Deer Ridge Valley - Preliminary Plat - 3301 Stanton Avenue

RE: Preliminary Plat, Deer Ridge Valley

We have reviewed the first (1st) submittal of the preliminary plat for Deer Ridge Valley, and have determined that the following conditions must be satisfied before plat approval can be granted.

TREE LOCATION SURVEY
DEER RIDGE VALLEY

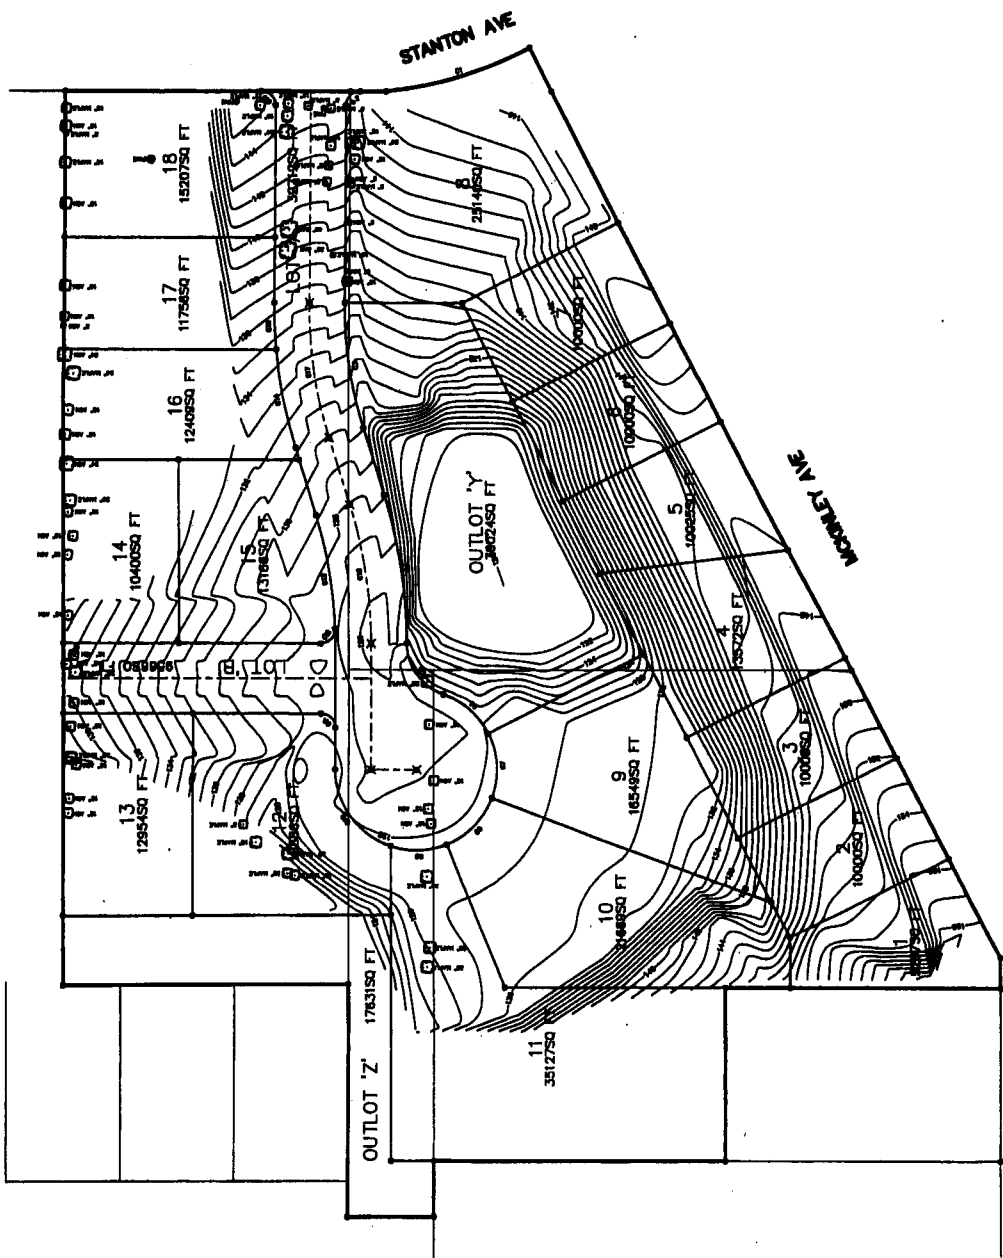
Staff recommends provision of preservation easements along the easternmost 10 feet of Lots 13, 14, 16, 17, and 18 in order to preserve the existing trees along the east site boundary within these lots. Staff also recommends provision of a preservation easement within the northernmost 50 feet of Lot 12 in order to preserve four mature trees, including two 12-inch maples, one 18 inch maple, and one 20-inch maple.

Staff recommends that the north/south street be shifted approximately 25 feet to the west in order to protect seven mature trees, including one 36-inch oak, one 40-inch oak, one 24-inch maple, one 18-inch maple, two 12-inch maples, and one pine tree. Staff believes this can be accomplished without losing any lots and that the resulting intersection with Stanton Avenue would still be adequately spaced from the intersection of Stanton and McKinley Avenues.

Staff recommends that the east/west street connection be shifted by approximately 30 feet either to the south or to the north in order to protect the 20-inch maple tree identified on the tree survey. This could result in the loss of one lot, as well as an additional 12-inch ash tree.

If staff's recommendations for shifting the streets are incorporated, the net loss of trees would be reduced by 8 trees totaling 162 caliper inches from 36 trees totaling 474 caliper inches to 28 trees totaling 312 caliper inches.
